# City of Santa Fe, New Mexico

# memo

2025-011703-HDRB, 424 San Antonio St., Downtown & Eastside Historic District, non-stated, Christopher Purvis, agent for Laura Bird, requests a status review with primary façade designation, if applicable, for the main residence and accessory structure.

Figure 3: Façade Diagram

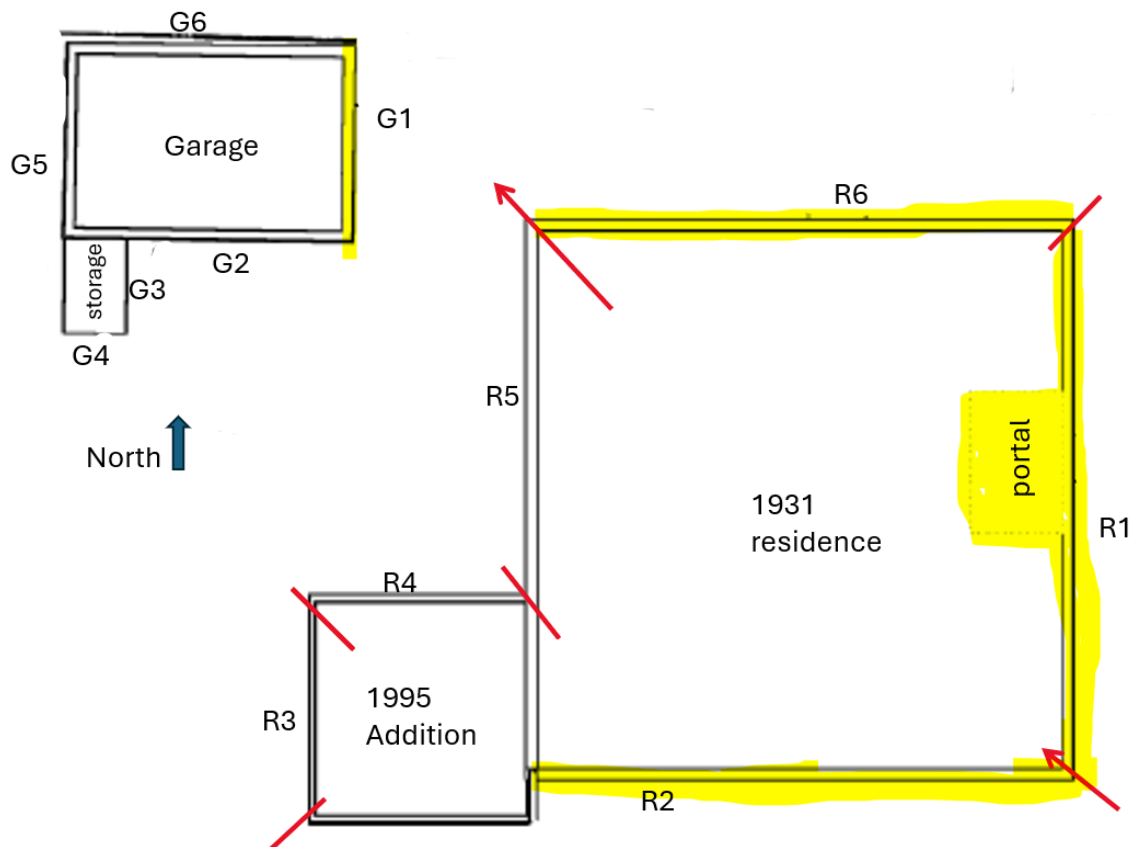
The historic associations and the architecture of the house are notable; however, several alterations to both the interior and exterior have been made. Therefore, staff find that the residence should be designated as a contributing structure. The single projecting viga on this northern elevation indicates that the exterior of the structure may have been altered at some point, and the west and south elevations each hold an addition from 1995. The highest integrity of the structure is in the east elevation. Staff recommend that the unaltered east façade, the north facade for the window openings, and the south façade, excluding the 1995 addition, be designated as the primary facades.

Further, we recommend that the garage also be designated as a contributing structure with the east, which contains the original layout of the garage and the original openings, as primary.

Staff recommends the historic status of the residential structure be designated as contributing with the east elevation (R1) including the interior of the portal, north elevation, (R6) and south elevation (R2), excluding the 1995 addition as the primary façades, and designate the accessory structure as contributing with the east (G1) as the primary façade, and designate the yard wall excluding the picket fence as contributing, per 14-5.2(C) Designation of Significant, Contributing or Noncontributing Status Within Historic Districts.
